Access Compliance Report

Public Rights-of-Way (Curb Ramps)

Intersection ID: 53894	Main Street: INVERNESS_BAY_RD	Cross Street: PERTH_MOOR_RD	Location: SW
ADA ID: 2CEF784CC577	Ramp Type: Perp	Initial Pass/Fail: Fail	Overall Compliance: No
Severity Score: 21.25			
Codes/Mitigation Info/Possible Solution		Field Measurements/Component Compliance

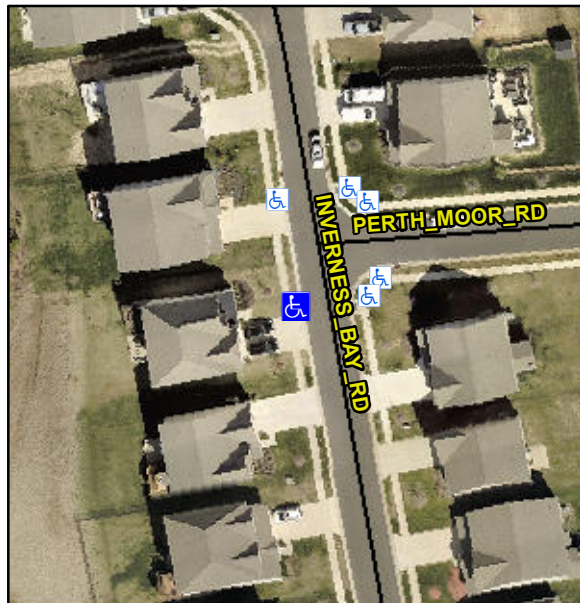
Not Found, R304.5.1, R304.2.2

Compliance	Description	Data	Compliance	Description	Data
N/A	Ramp Length (in)	48.0	No	Ramp Slope (%)	9.2
No	Ramp Width (in)	47.0	Yes	Ramp XSlope (%)	1.2
N/A	Flare Type LT	N/A	N/A	Flare Type RT	N/A
N/A	Flare Slope LT (%)	N/A	N/A	Flare Slope RT (%)	N/A
N/A	Flare Traversable LT?	N/A	N/A	Flare Traversable RT?	N/A
N/A	Landing Length (in)	N/A	N/A	DWS Provided?	N/A
N/A	Landing Width (in)	N/A	N/A	DWS Contrast?	N/A
N/A	Landing Slope (%)	N/A	N/A	DWS Length (in)	N/A
N/A	Landing X Slope (%)	N/A	N/A	DWS Full Width?	N/A
N/A	Landing Curb? (Y/N)	N/A	N/A	DWS Offset (in)	N/A
N/A	Shared Landing?	N/A			
N/A	Gutter Ponding?	N/A	N/A	Gutter Slope (%)	N/A
N/A	Gutter Lip Ht (in)	1.0	N/A	Gutter X Slope (%)	N/A
N/A	Painted X Walk1?	No	N/A	Painted X Walk2?	N/A
	X Walk 1 Direction	To E		X Walk 2 Direction	N/A
N/A	X Walk 1 Width (in)	N/A	N/A	X Walk 2 Width (in)	N/A
	X Walk 1 Slope (%)	1.8		X Walk 2 Slope (%)	N/A
	X Walk 1 X Slope (%)	0.3		X Walk 2 X Slope (%)	N/A

Remove & Replace Entire Ramp.
